**RE: Creekside PRD - Response to Technical Review #2
PA23-005**

Please refer to our responses below which address all review comments received from the City of Marysville dated 8/28 for planning, 9/25 for surface water, and 9/27 for traffic. Located at 7808 40th Street, 7811 & 7715 40th Street NE, APNs 29050200100200, 29050200100300, and 29050200100400. You will find the markup comments listed in the order that they were written followed by our response in *italics*.

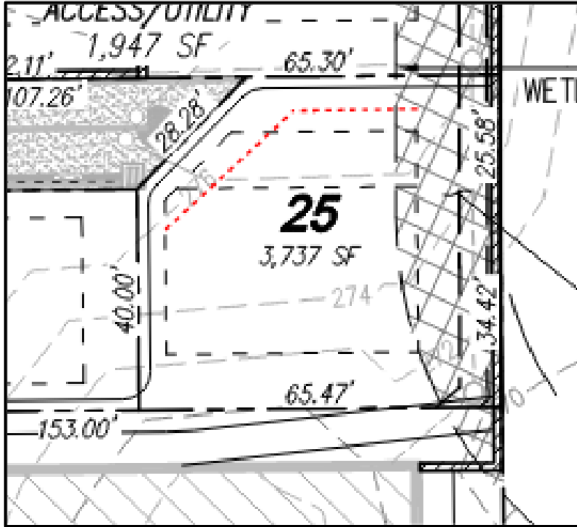
2. For Net Project Area calculations, only the non-transferrable critical areas should be removed. This would be the stream channel only on this site. Please revise the calculation appropriately.

"Net project area" means the gross project area minus:

- (1) Floodplains;
- (2) **Nontransferable critical areas (e.g., stream channels) per MMC 22E.010.360;**
- (3) Utility easements 30 feet wide or greater;
- (4) Publicly owned community facility land;
- (5) Storm water detention facility tracts or easements (unless underground and usable for recreation). If stormwater detention areas are designed and constructed to meet low impact development standards, 50 percent of the area used for detention may be counted as net project area; and

Response: After discussion with City staff given the amount of non-transferrable credits onsite, the City is allowing an adjustment to the net project area calculation provided that additional active open space amenities are provided within the development. These amenities are shown on the landscape plans.

**DENSITY, DIMENSION AND PARKING
PER MMC 22G.080.080**

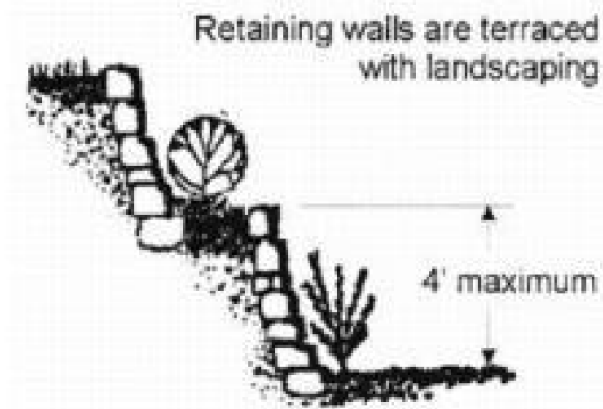
4. Bulk and dimensional standards for a PRD are outlined in MMC 22G.080.080. The table on sheet 2 of the Preliminary Site plan indicates a lot size that does not meet the minimum; see below.

Response: Lot 37 that was previously under 3,500 sf has been revised to meet the minimum lot area requirement. The table has been updated accordingly.

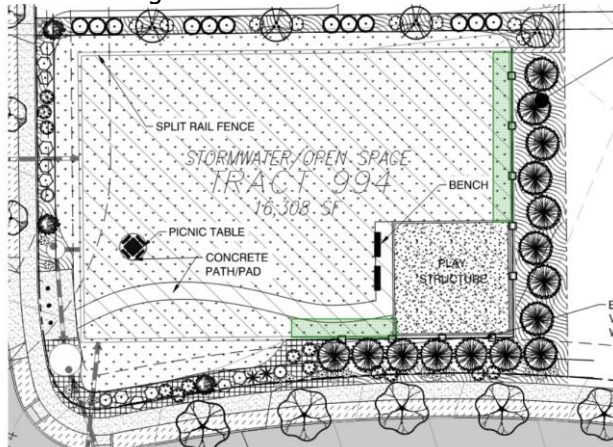
6. Pursuant to MMC 22D.050.030(4)(e), retaining walls taller than four feet shall be terraced so that no individual segment is taller than four feet. Walls between of lots 44 and 49, 27 and 24, along the southern boundary lots 29-35 , adjacent to 44th Street, and in scattered other locations, exceeding four feet will be required to meet the terracing requirements below. Lots directly abutting the wetland and *not visible* from adjacent lots or roadways are not required to meet these standards. Compliance will be verified during civil construction plan review.

Tall retaining walls must be terraced with landscaping as depicted below.

Response: All referenced retaining walls have been revised to 4' maximum. See sheet RD-02 for the updated wall and lot grading design. Specific retaining wall designs will be provided as part of the future grading permit submittal package.
